**REQUEST ENCROACHMENT INTO
RANDOLPH ST. BETWEEN
CENTER ST. AND GRATIOT AVE.**

**CITY OF DETROIT
CITY ENGINEERING DIVISION
MAPS & RECORDS BUREAU**

JOB NO. 25-63

DRWG. NO. 065

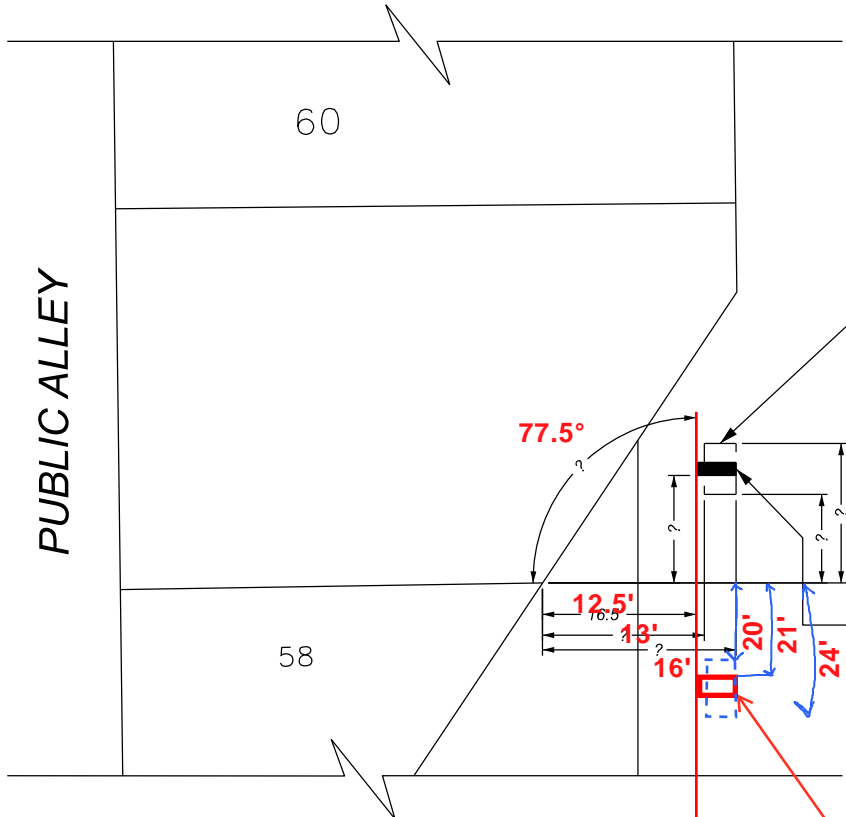
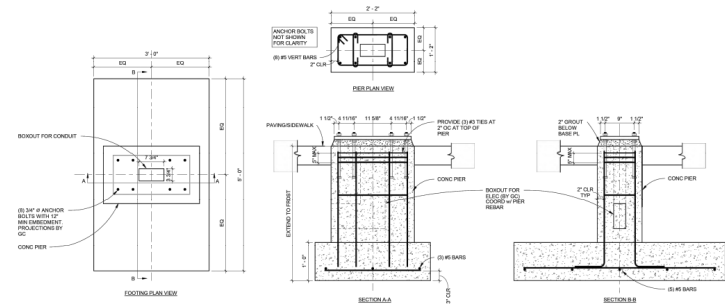
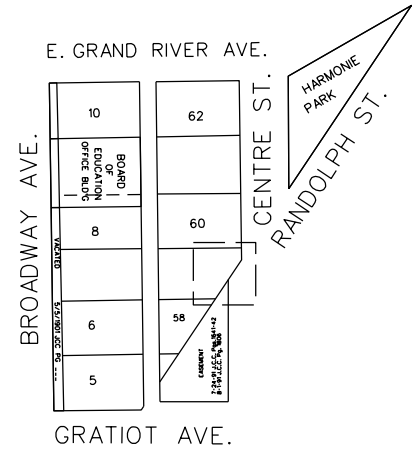
REMOVE EX. PLA
INSTALL PROPO
(WHAT TYPE?)
(0' TO ? BELOW GRADE)

PLEASE PROVIDE DIMENSIONS FOR EXISTING STREET LIGHT POLE, HANDHOLE LOCATION, AND UNDER GROUND CONDUIT INFO
